Serial No.: 10/667,122

Brake Disk for Vehicles

REMARKS

FIG. 1

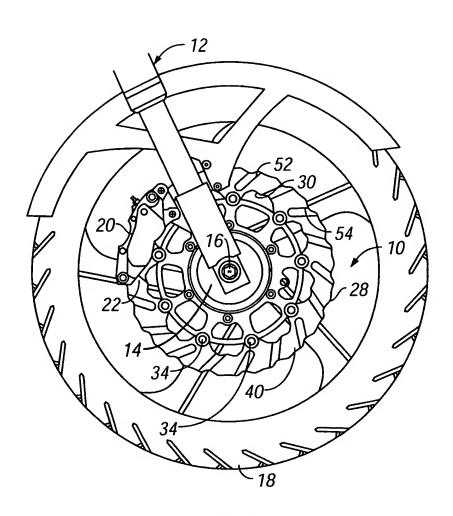
The Examiner, in paragraph 2 objected to the drawings in that reference number 14 was inadvertently omitted from the formal drawings submitted 29 March 2004. Applicant submits herewith, in both redlined and clean versions, new drawing sheets correcting the omission. The correction to Fig. 1 includes element numbering for element 14.

FIG. 2

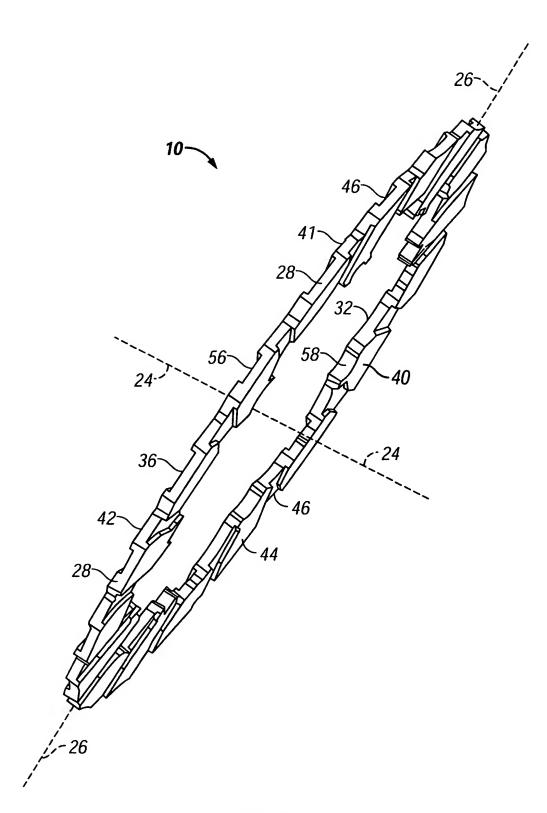
The Examiner objected to the drawings on the baisis of question marks appearing in Fig. 2 in the formal submission. This has been corrected by amending Fig. 2 to replace "??" with 40, (and with the aforementioned correction of changing the global designator form 40 to 10 in the same figure). Redline and clean versions of this are submitted herewith.

In addition, Applicant has provided correction by adding the global designator 10 to Figs. 2, 3 and 4. Redlined and clean drawing pages are provided for these figures, as well. Although there are no changes to the remaining figures, clean pages are submitted for the entire drawing set.
